***Proposed District
Plan Change 60***

Churton Park Suburban Centre Rezoning

13 August 2007
Wellington City District Plan

Annotated provisions of the Operative District Plan showing proposed changes

Churton Park Village Concept Plan

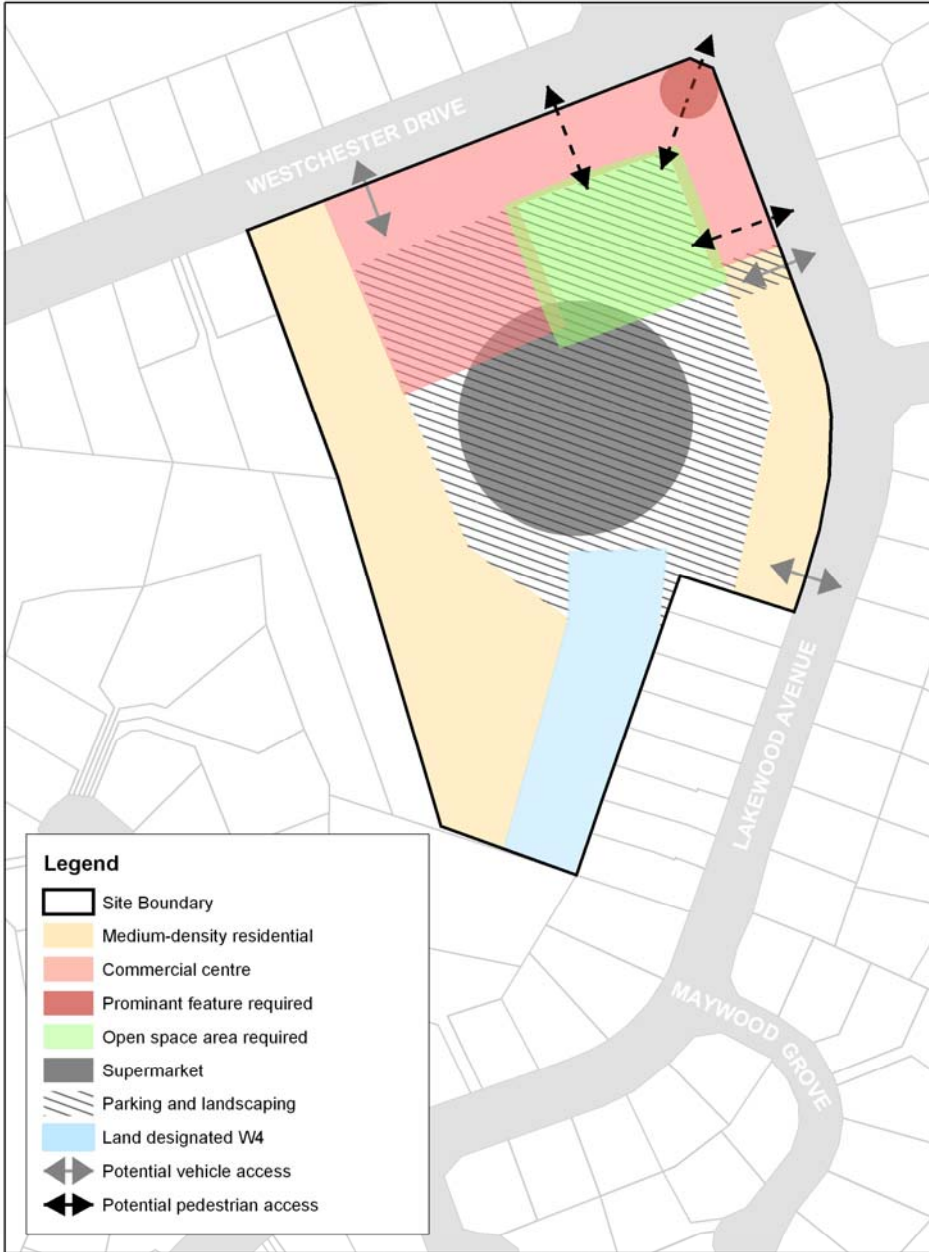
3.0 Map

The different activity areas shown on the map *do not* represent the absolute location, footprint or specific land area to be used. Rather, these are diagrammatic representations of the general locations for buildings and activities. There is no specific requirement to either develop adjoined or separate buildings in any on part of the village. The final size, location and design of any component of the village required by the Concept Plan and shown on the map will be assessed through the resource consent process. Any subdivision will also be assessed through the resource consent process for compliance with the requirements and compatibility with the map of the Concept Plan. Additionally, given that timing of development or subdivision of any part of the village is uncertain, the Concept Plan anticipates any balance areas *not* being developed, but remaining in grass cover or be landscape planted awaiting development. In particular, the plan does not intend that undeveloped areas be temporarily developed or used for car parking.

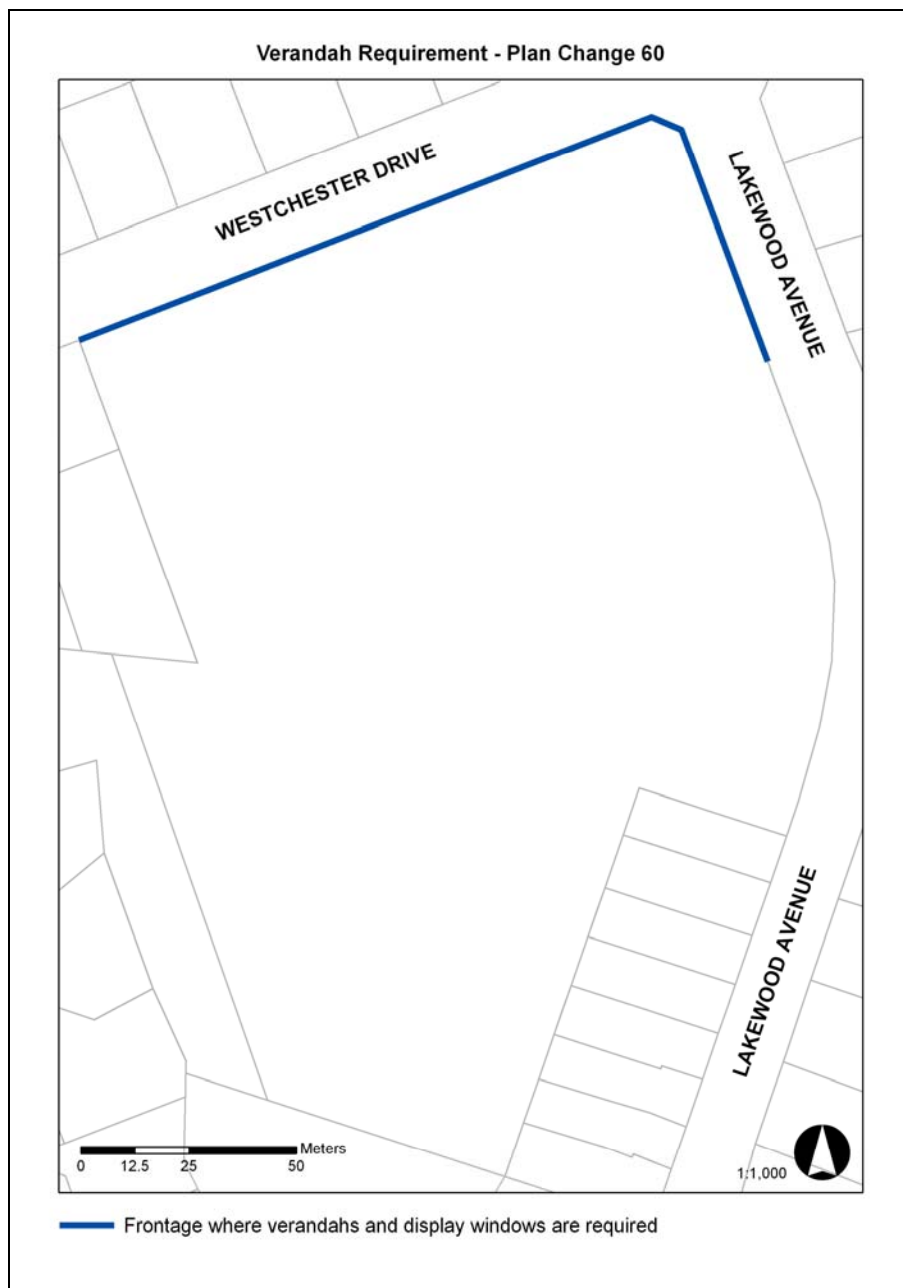
10.0 Amend planning map 47 by including the following diagram identifying the display window and verandah requirements as shown:

Appendix 1 - Rezoning of Residential land on Lot 3 DP 311793, Churton Park

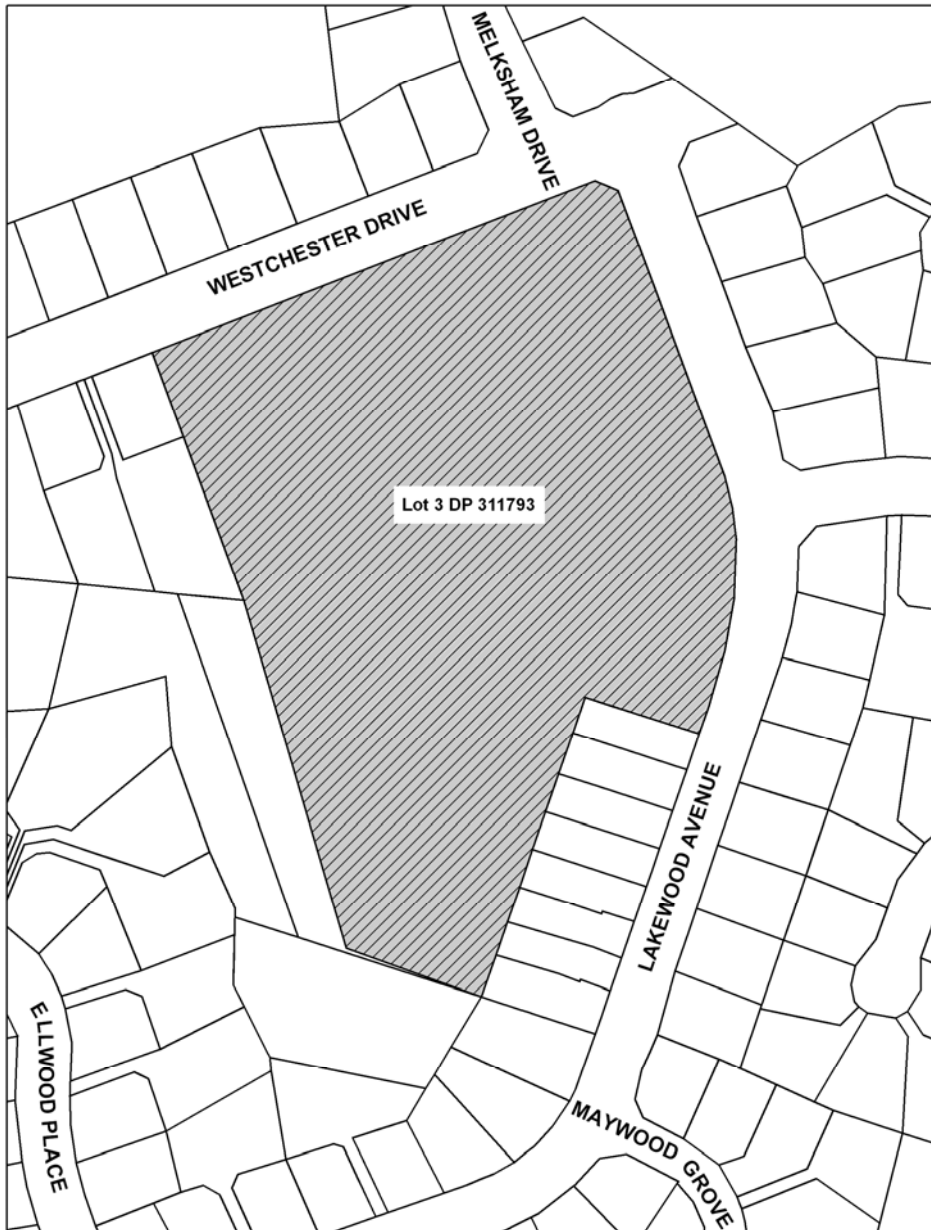
9.0 Amend planning map 26 by colouring the site on the south west corner of Westchester Drive and Lakewood Avenue for Suburban Centres zone (See Appendix 1)

Land currently zoned Outer Residential
to be zoned Suburban Centre
